To
cc
bcc
Subject Fw: Draft Environmental Impact Statement

To "swcorridor@co.hennepin.mn.us"
 <swcorridor@co.hennepin.mn.us>
 cc
 bcc
 Subject DEIS Comment - Wooddale Ave Intersection Safety

I would like to submit comments in response to the SOUTHWEST TRANSITWAY DRAFT ENVIRONMENTAL IMPACT STATEMENT. As a civil engineer and a resident of St. Louis Park, I support the Southwest Corridor light rail in my neighborhood. However, I am concerned about the safety of motorists and pedestrians at the Wooddale Ave intersection, which is planned to be at-grade. I see the construction of the light rail as an opportunity to improve safety for pedestrians and motorists.

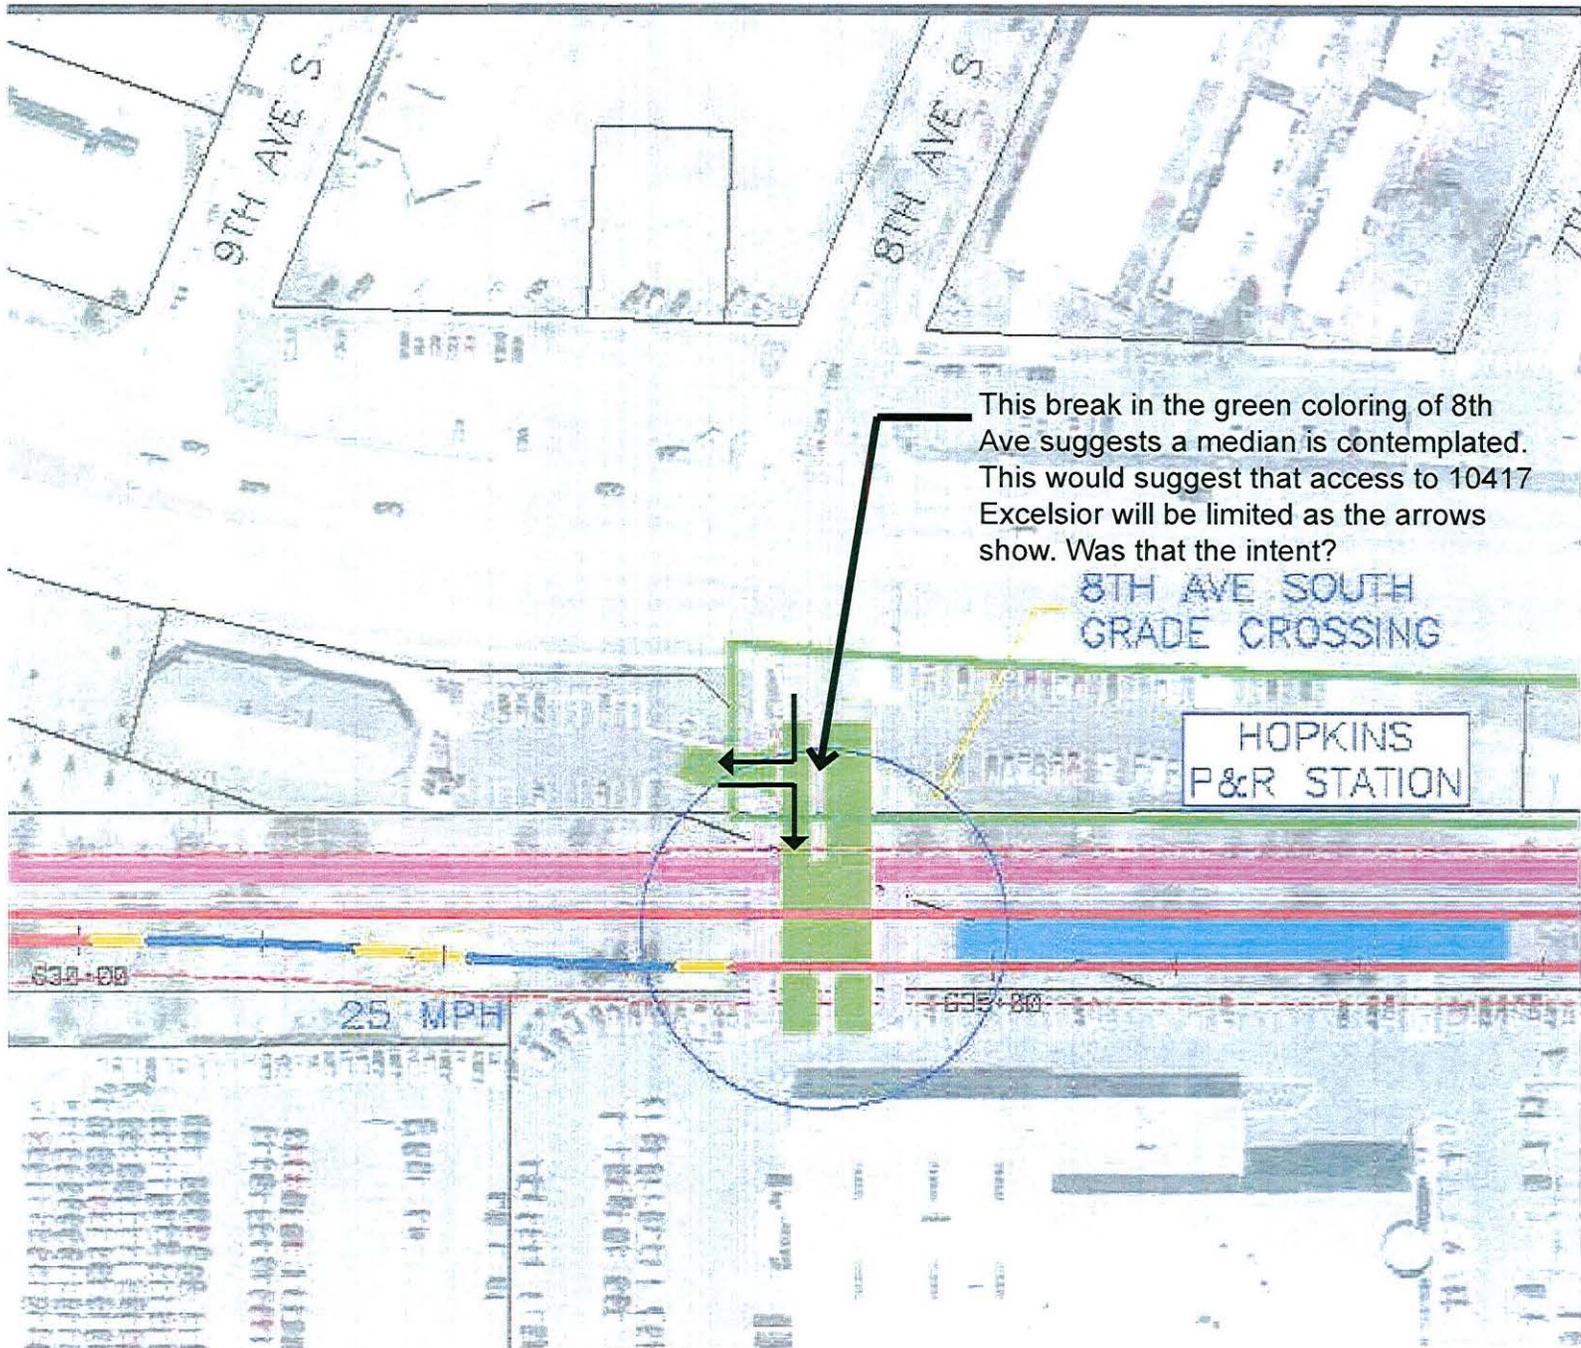
Referring to the attached drawing, my question is what is the meaning of the pink line in the middle of the 8th Avenue extension south of Excelsior Blvd.? If that pink line is intended to suggest a raised center island, I need to immediately indicate that the portion of the pink line across our driveway is a serious problem. Looking at the drawing, one obvious problem is that users of our property would have no legal means of exiting from the parking lot. Such users would have to turn south and trespass on the Hopkins Honda property in order to exit to Excelsior Blvd. Furthermore, such a restriction on exiting from our property would violate an easement agreement we executed with the City, which assures that users of our property will have direct access to Excelsior Blvd. for both ingress and egress purposes via the southerly extension of 8th Avenue.

Please clarify the intention of the referenced pink line in the attached drawing. If this is meant to suggest a raised center island, please indicate how you intend to proceed to eliminate the raised island blocking our driveway. It seems that one option would be to begin the raised island on the south side of our driveway and utilize pavement striping from there north to Excelsior Blvd.

This break in the green coloring of 8th Ave suggests a median is contemplated. This would suggest that access to 10417 Excelsior will be limited as the arrows show. Was that the intent?

I will ask HDR staff for a response to your question, but it may require more clarification. The trail is indicated in pink on the conceptual engineering drawings with the green indicating roadway reconstruction.

In response to your technical question about the pink line, it refers to the reconstructed interim use bike trail that is currently housed within the HCRRA right-of-way.
